Response to Wexford County Council LRD Opinion

For Development at Kilnahue, Gorey, Co. Wexford

on behalf of Glenveagh Homes Ltd.

December 2025

Figure 1 Phasing Plan

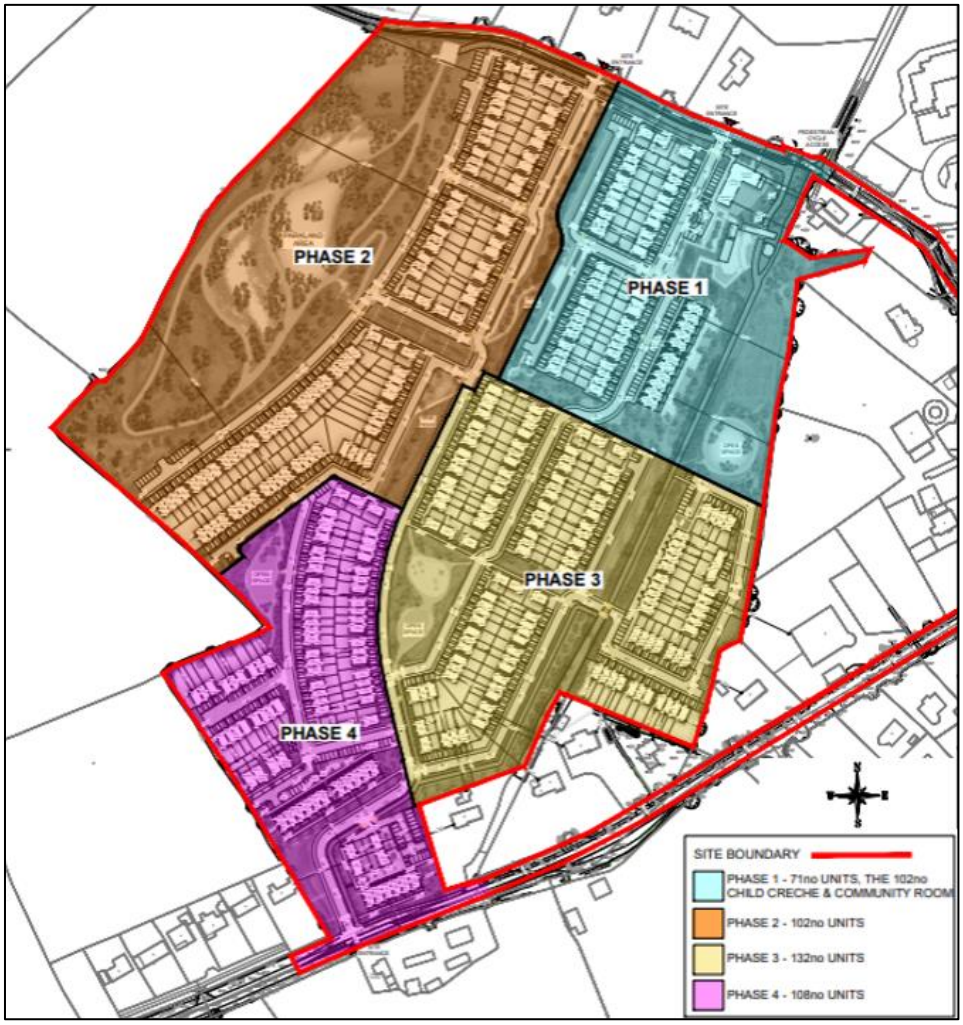
A detailed phasing plan will be required which identifies the delivery of essential infrastructure for the site.

The proposed development will be carried out over a period of 48 months. This will be completed throughout 4 phases, as per the below phasing plan.

Please see the CEMP prepared by AWN Consulting on the phasing and proposed construction.
